Lower Hill Redevelopment
First Amendment to Preliminary Land Development Plan

Amendment to Section 1: Introduction & Section 2: Regulating Plans

Figure 2.25 Accessible Streets Diagram

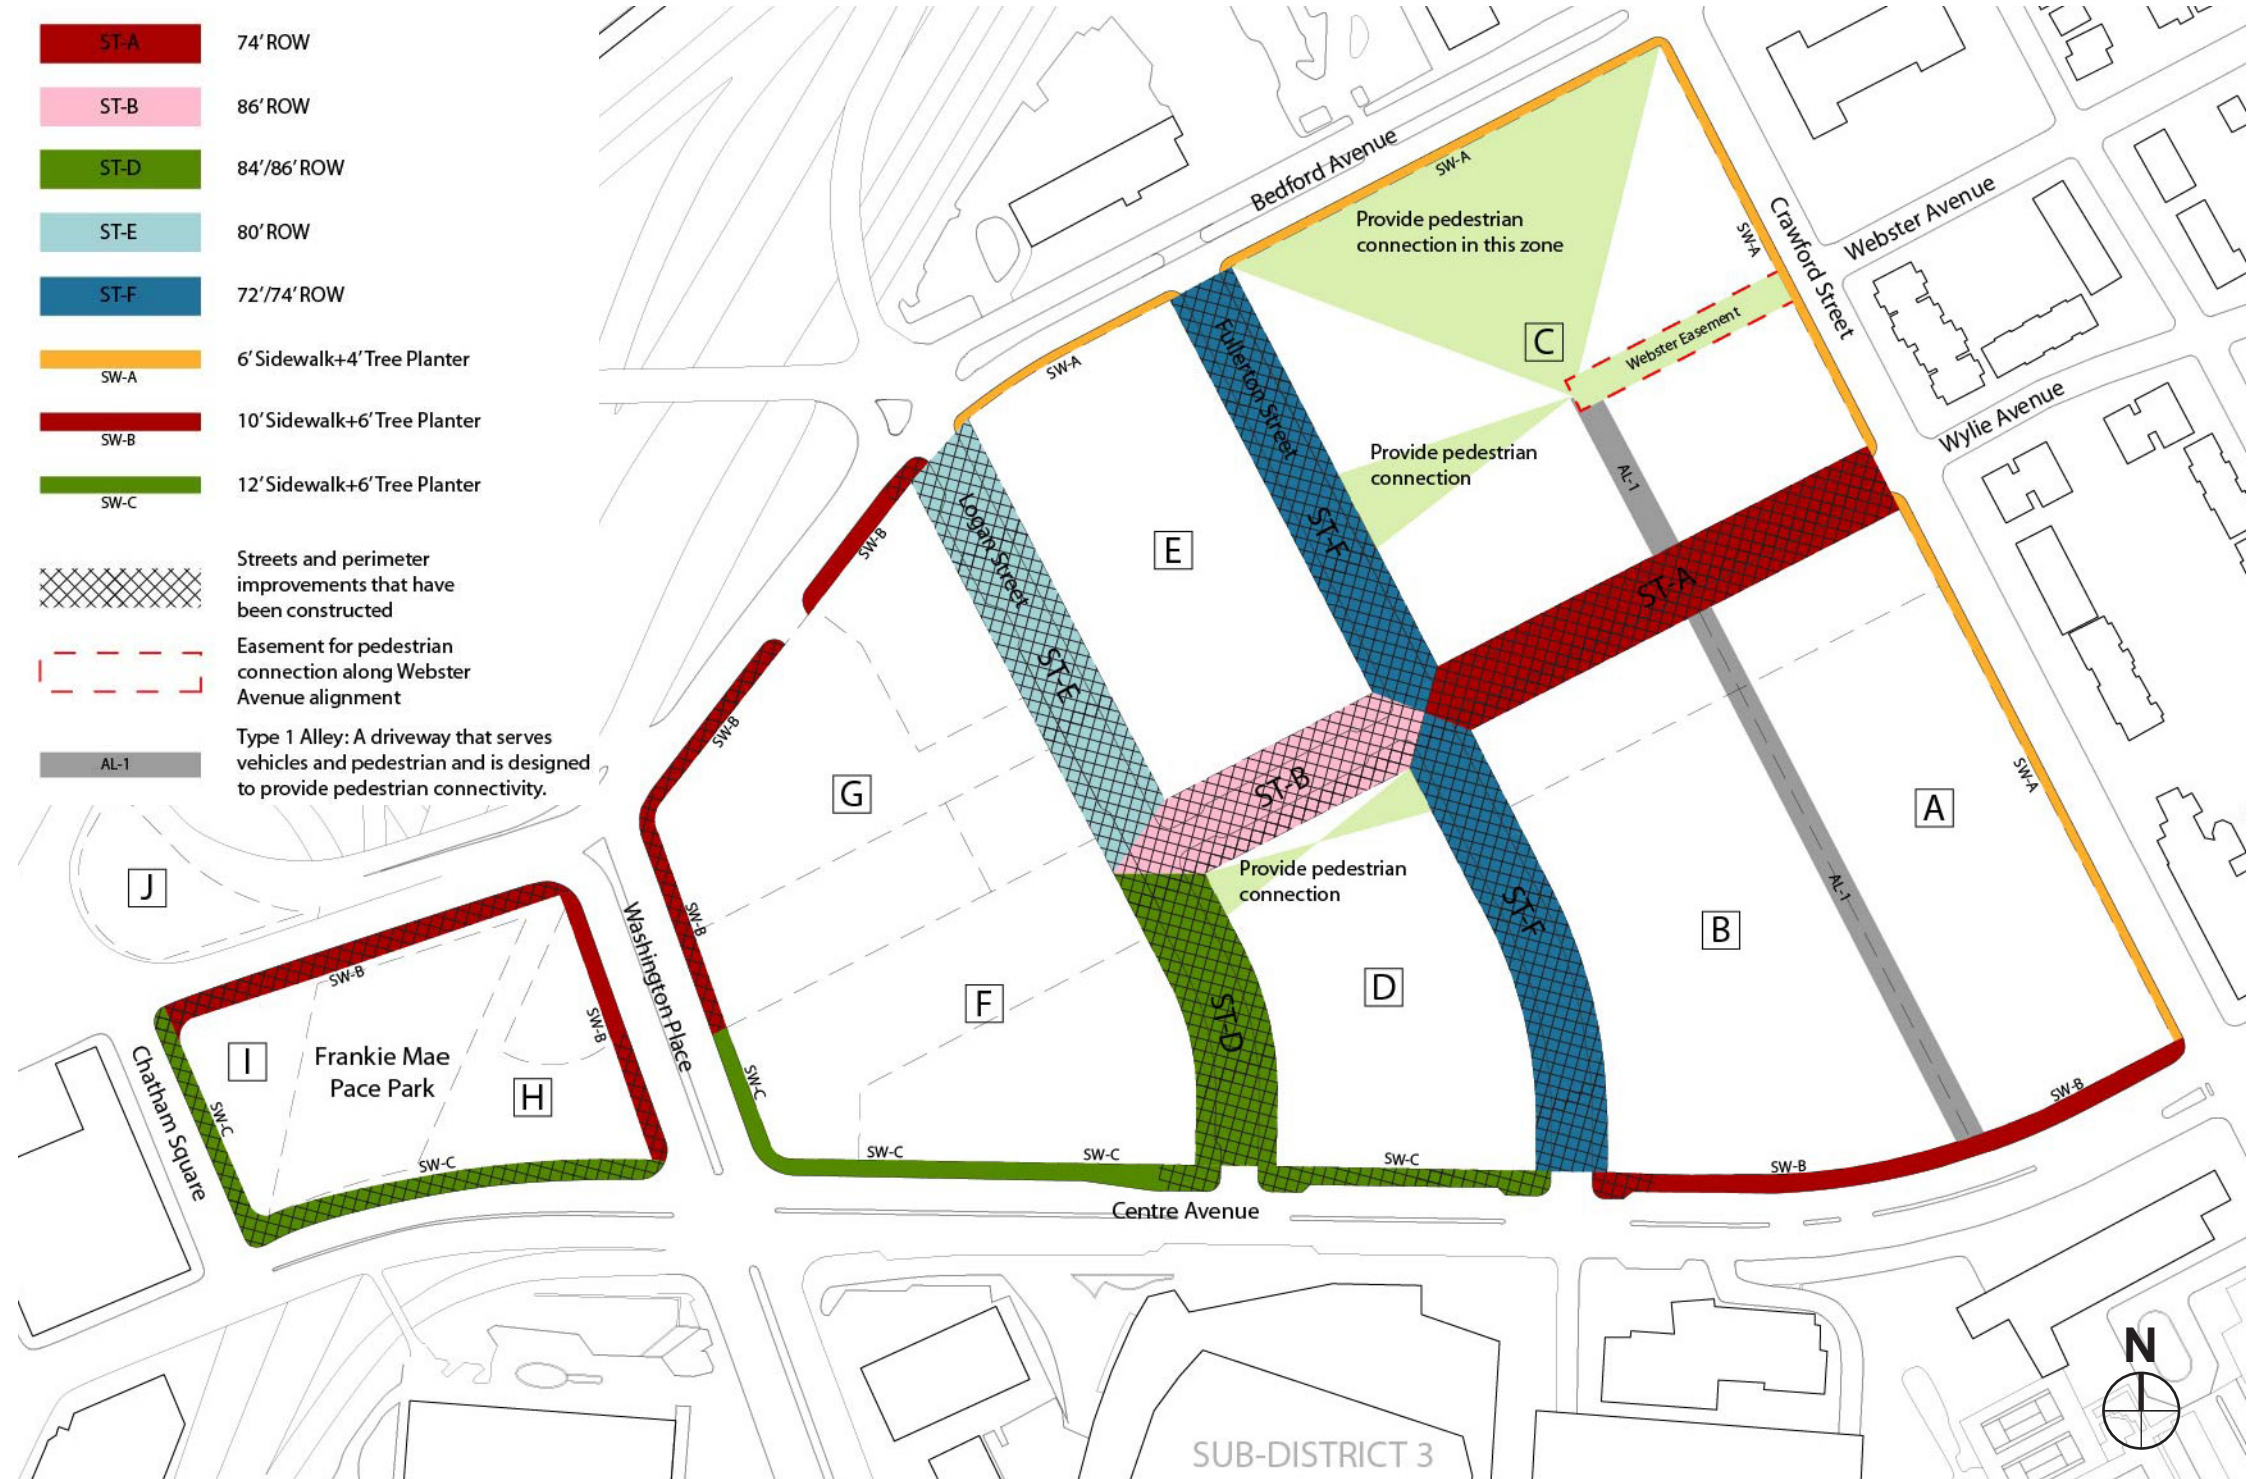
Figures 2.25 and 2.26 are revised to reflect the Block revisions identified in Section 2.4 and as follows:

Blocks A, B and C are modified, the required easement aligning with Webster Street is retained.

Pedestrian connection zones are retained and modified in Blocks A, B and C.

Pedestrian connection zones are added in Block D.

Updates to Figure 2.43 and 2.44 (Shown right)

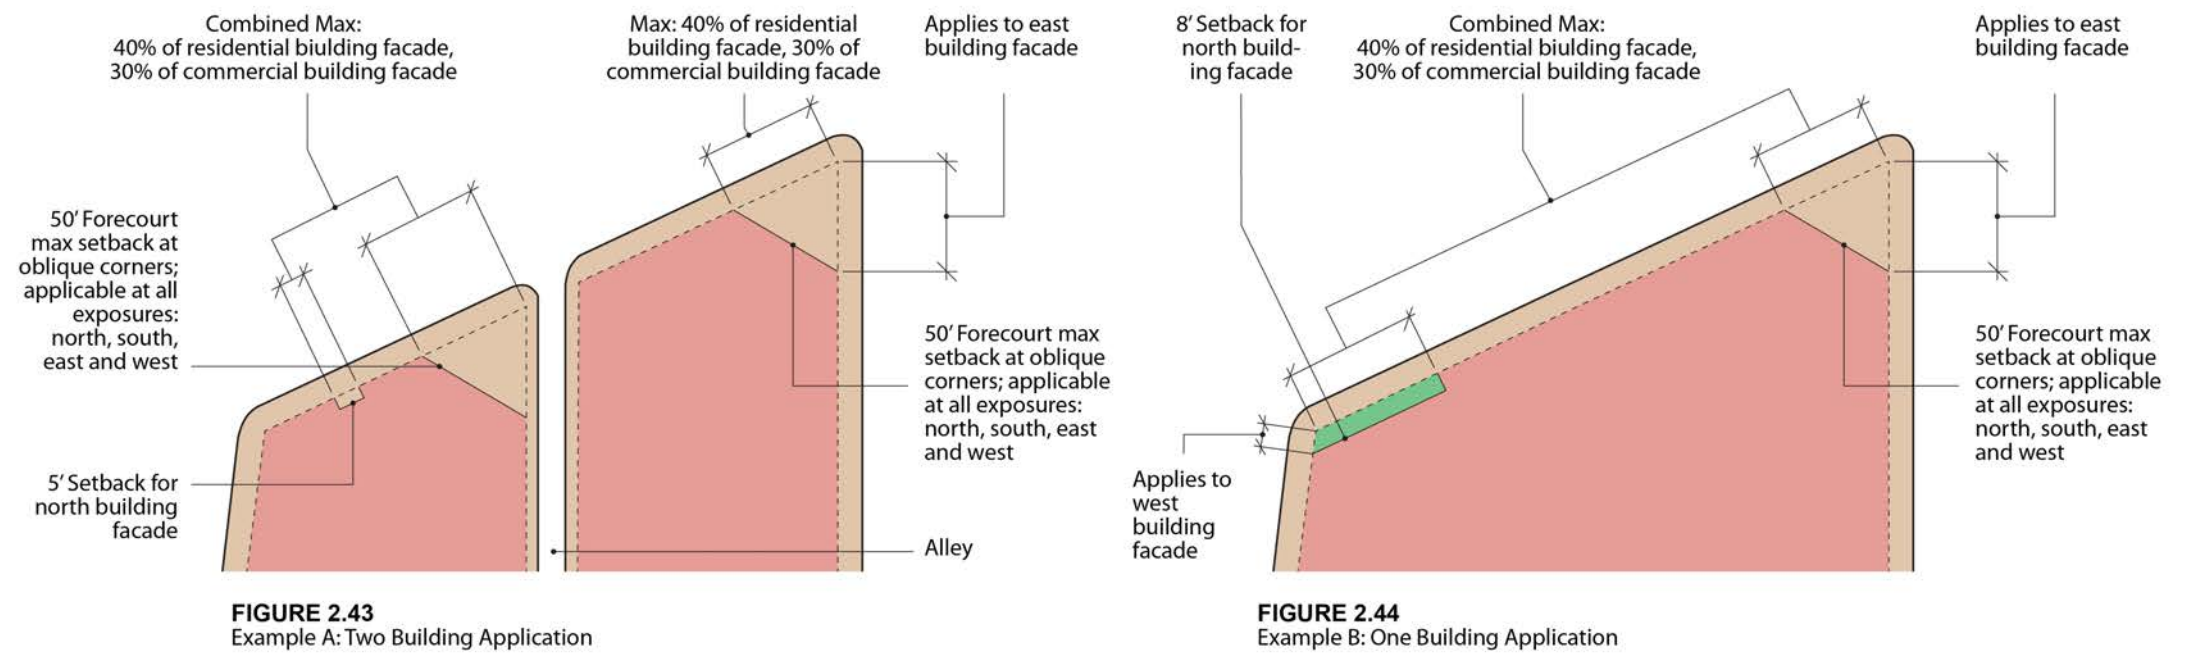
2.7.2 Frontage Type Applications
Figures 2.43 and 2.44 are revised to increase the allowable Forecourt setback at oblique corners to 50' for commercial buildings, matching the dimension provided for residential buildings. The dimension is clarified to be applicable at all exposures; north, south, east and west.

Figure 2.59 Minimum height requirement diagram

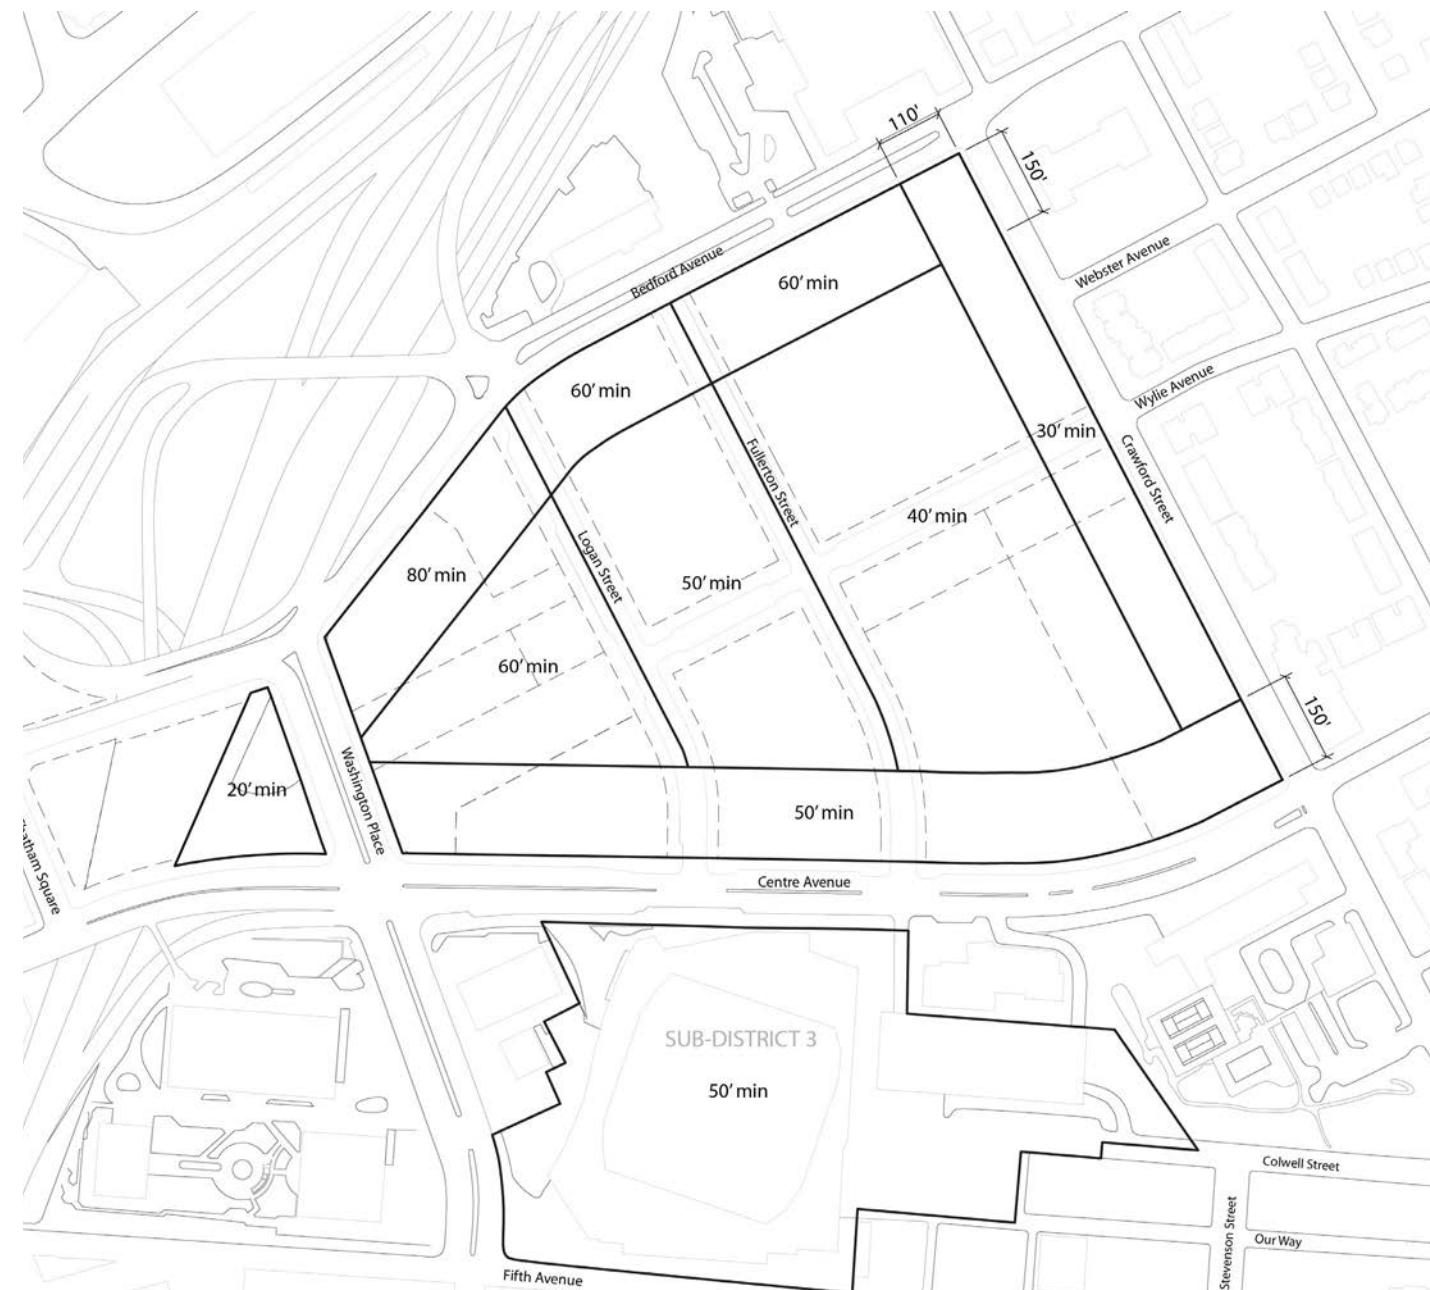
Figures 2.59 and 2.60 are revised to reflect the Block revisions identified in Section 2.4. Height Zones b, d, h, i and l are revised to correct discrepancies, these shall follow the criteria established in the SP-11 Lower Hill, Section 909.01.R.5(c), Height Standards.

Figure 2.66 Parking and Service Regulating Plan

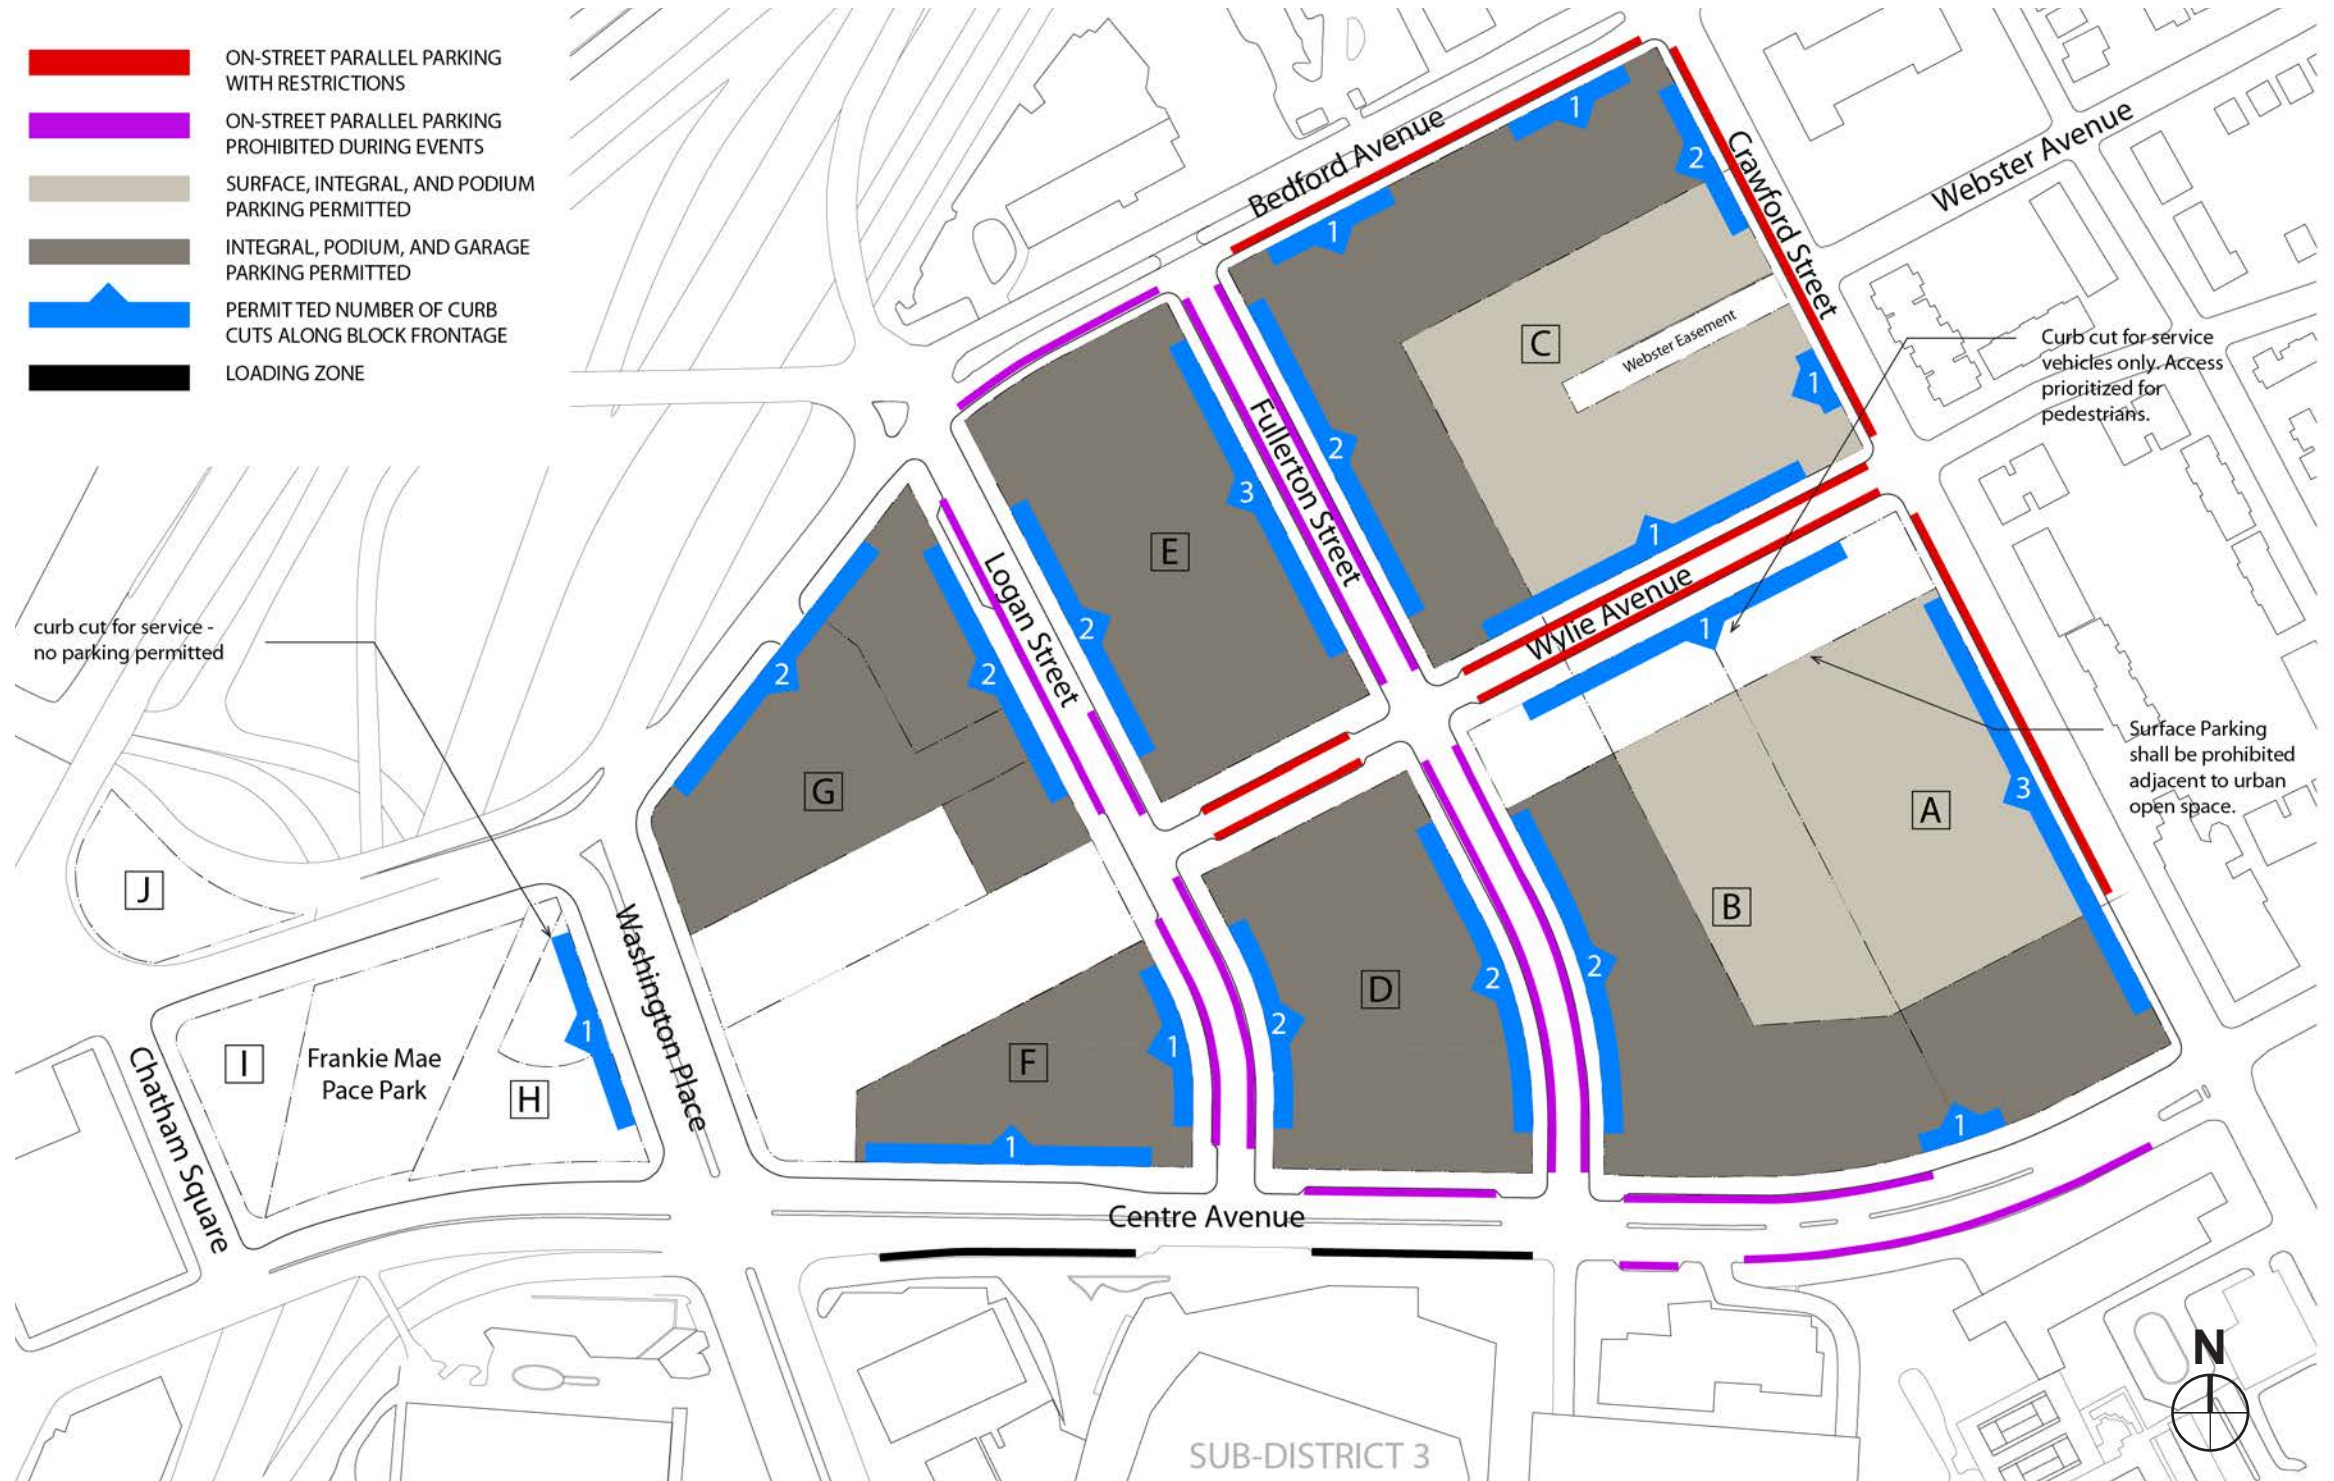
Figure 2.66 is revised to reflect the Block revisions identified in Section 2.4 and as follows: (1) one curb cut between Block A1 and B1 is permissible along Centre Avenue, (2) Three curb cuts on Block E are permissible along Fullerton Street, (3) one curb cut on Block F is permissible along Centre Avenue. (4) one curb cut on Block H-R is permissible along Washington Place for building services.

Figure 3.1 Sustainable and Accessible Streets Diagram

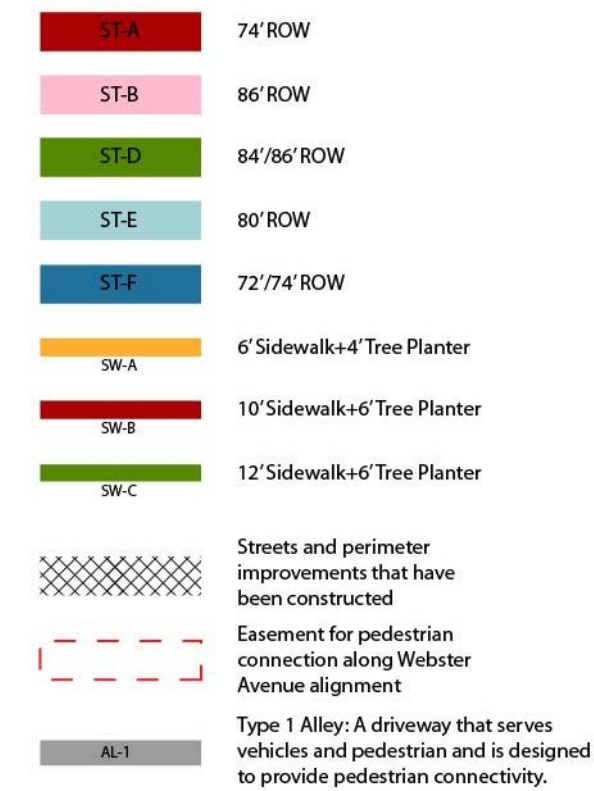
Figures 3.1 and 3.2 are revised to reflect the Block revisions identified in Section 2.4 and as follows:

Blocks A, B and C are modified, the required easement aligning with Webster Street is retained.

Pedestrian connection zones are retained and modified in Blocks A, B and C.

Pedestrian connection zones are added in Block D.
